Serial No. **10/731,445**

Docket No. **K-0589**

Amdt. dated March 20, 2006

Reply to Office Action of October 18, 2005

FIG. 1
~~Related Art~~

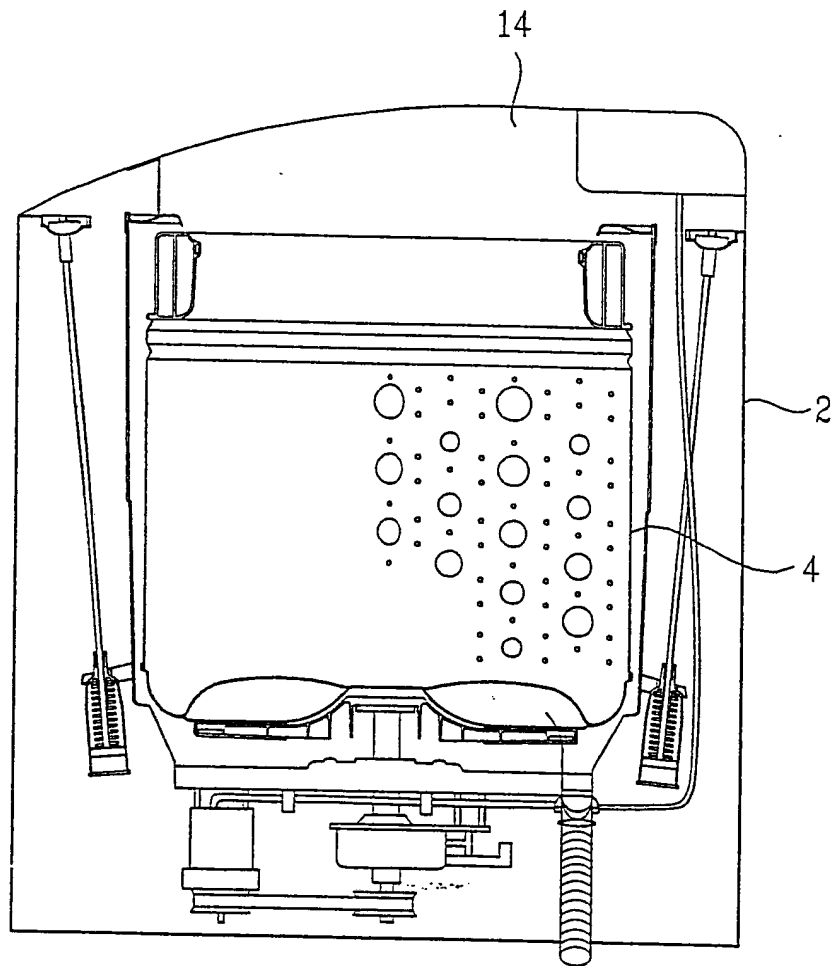
The Office Action objects to the drawings under 37 CFR 1.83(a), alleging that the “cabinet for a home appliance” recited in claims 1 and 7, and the “cabinet of a home appliance having a sectioned lid” recited in claim 12 are not shown in the drawings. Applicants respectfully disagree.

The home appliance shown in Figures 1 and 2 of the present application includes a cabinet 2 with a sectioned lid 14, the sectioned lid 14 including front and rear lids 15 and 16, respectively. Figure 3 is a cross section of a related art rear lid 16 used in the home appliance, taken along line A-A of Figure 2, which is just in front of the rear lid’s hinged attachment to the cabinet 2 of the home appliance (see also paragraph 5 of the present application).

Further, it is respectfully submitted that Figures 1 and 2 of the present application clearly show a cabinet for a home appliance having a sectioned lid comprising a first section and a second section having a first end hinge-coupled to the first section, as recited in independent claim 12, and a second end hinge-coupled to the home appliance, as recited in claim 13. As set forth above, Figure 2 clearly shows that the sectioned lid 14 includes front and rear lids 15 and 16, and paragraph 5 of the present application explains that the rear lid 16 is hinge-coupled at one end to the front lid, and at its opposite end to the home appliance. It would be well understood by one of ordinary skill in the art, especially when taken in light of Figure 2 and its accompanying description in the specification, that these two portions 15 and 16 of the sectioned lid 14 are hinge-coupled to allow the sectioned lid 14 to function in the manner described (see also paragraph 4 of the present application).

The attached drawings include changes to Figures 1 and 2. These sheets, which include Figures 1 and 2 replace the original sheets including Figures 1 and 2. Figures 1 and 2 have been amended to remove the legend "Related Art."
